Project TransmiT: Impact Assessment of industry's proposals (CMP213) to change the electricity transmission charging methodology

Annex 1: Responses to consultation questions

Figure 2: De-rated Capacity Margin - Diversity I

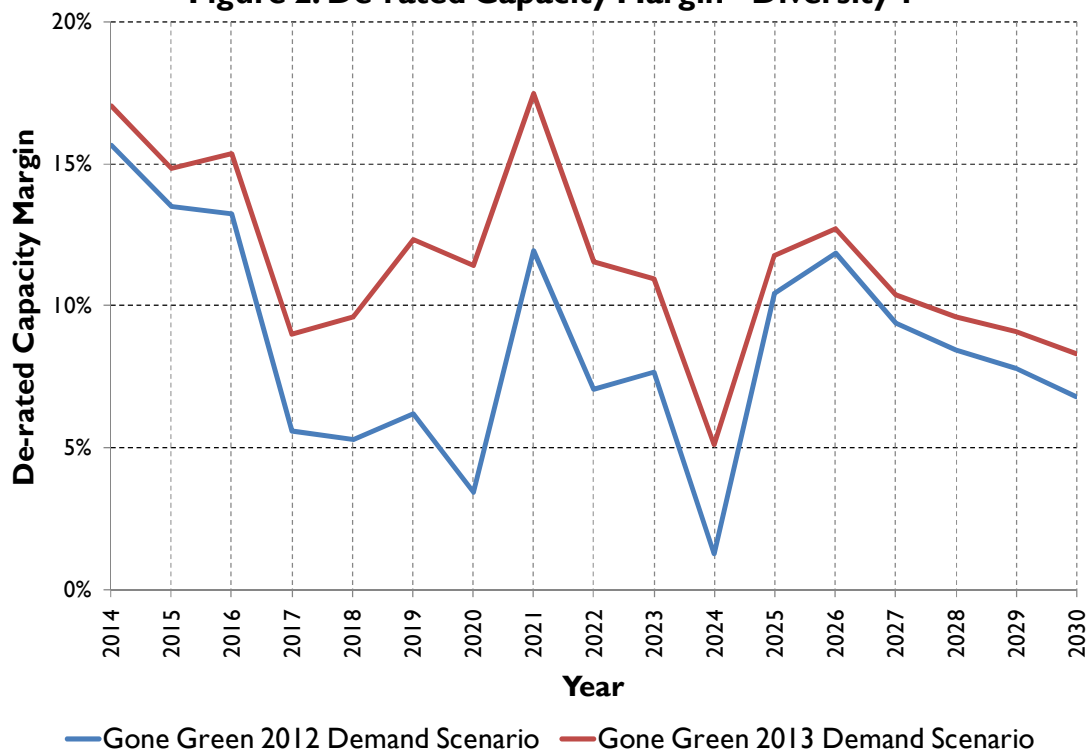
There are a number of comments which highlight that the Gone Green 2012 demand background used within the CMP213 modelling has now been superseded by the Gone Green 2013 scenario, and how capacity margins would evolve under this scenario. As a result, we have re-run our analysis for Status Quo and Diversity 1 using demand data based on the 2013 Gone Green Scenario. As this scenario forecasts lower demand than the 2012 scenario previously used, there is a resulting decrease in wholesale costs over the period concerned (as less energy is traded in the wholesale market). Most notably, there is a resulting increase in capacity margins. The following charts depict this.

The only other noticeable effects of the demand reduction are a decrease in the level of CCGT build under the Diversity 1 model, and a decrease in CCGT CCS generation build under both models. The level of renewable build remains identical to that previously modelled.
